DIABLO CANYON UNIT 1
INDEPENDENT DESIGN VERIFICATION PROGRAM
SOILS REPORT - INTAKE STRUCTURE
SLIDING RESISTANCE
ITR # 40
REVISION 0

Docket No. 50-275
License No. DPR-76

**DIABLO CANYON NUCLEAR POWER PLANT - UNIT 1
INDEPENDENT DESIGN VERIFICATION PROGRAM**

SOILS - INTAKE STRUCTURE SLIDING RESISTANCE

Figure 4
 Intake Structure
 Foundation Profile A-A

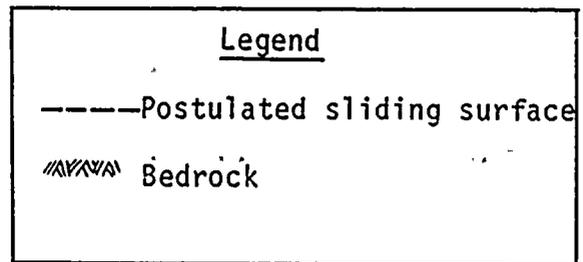
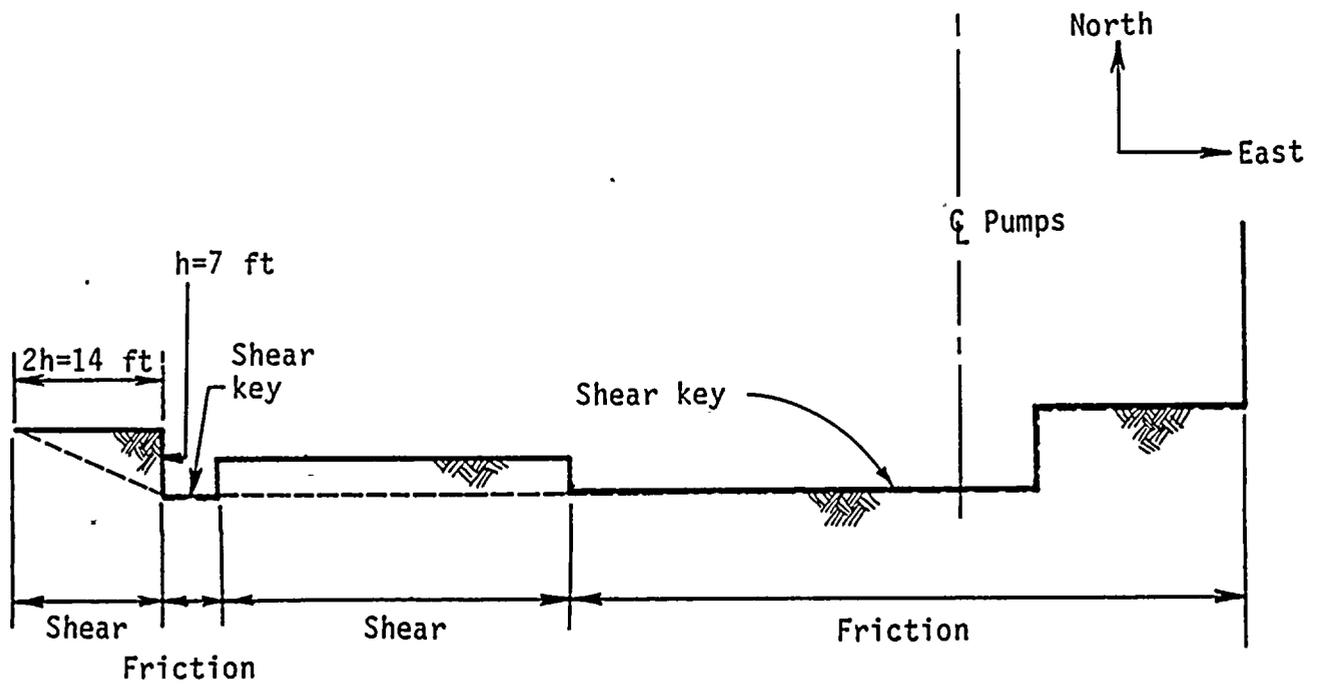
Figure 3 shows the interface between the intake structure and the bedrock which the IDVP determined by reviewing the concrete lift-pour drawings. The IDVP postulated the sliding surface shown in Figure 4.

A comparison of the IDVP and HLA methods for postulating sliding surface and determining resistive forces showed that the two analyses were similar with the following three exceptions:

1. The IDVP accounted for the resistive action west of the outboard key as shear along a 2 to 1 horizontal to vertical slope. HLA accounted for this action by calculating (2) times cohesion (c).

HLA	IDVP
2 (c) h	$c \sqrt{h^2 + (2h)^2}$
2 (3ksf) 7 ft	3 ksf (15.7 ft)
= 42 k/ft	= 47 k/ft

$$c = 3 \text{ ksf}$$
$$h = 7 \text{ ft (see Figure 4)}$$

The differences in the HLA and IDVP results have been examined. As shown previously, the HLA results for cases 1 and 2 produce smaller (conservative) resistive forces. While the HLA results did not explicitly specify a bouyant structural weight, the IDVP determined that it was considered in a subsequent design analysis. Therefore, this difference had no impact.
